NUMBER 15-86-91

SERVICE BULLETIN

APPLICABILITY 1991 MY LEGACY "L" MODELS WITH MANUAL TRANSMISSION

SUBJECT: LEGACY CRUISE CONTROL INSTALLATION 91MY MANUAL TRANSMISSION

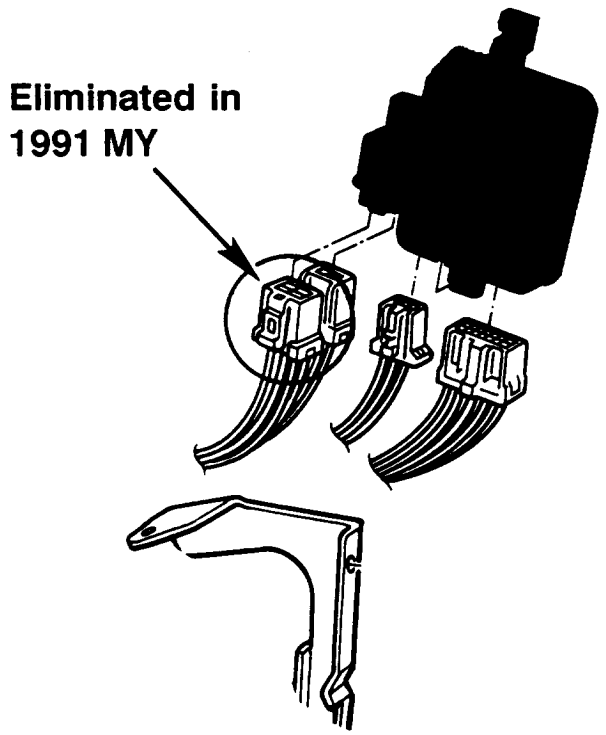
The wiring logic of the vehicle harness has been modified on 1991 vehicles. This change eliminates the need for the clutch relay. The clutch disconnect function is accomplished through the clutch switch on 1991 manual transmission Legacy vehicles. Wiring connector B83 (4 Pin) referred to in step E-6 and the schematic is not equipped in the vehicle harness for 1991.

Therefore, the clutch relay should not be connected. We recommend removing this relay from the bracket prior to kit installation. This will prevent confusion during later servicing.

NOTE: The clutch relay must be connected on 1990 vehicles.
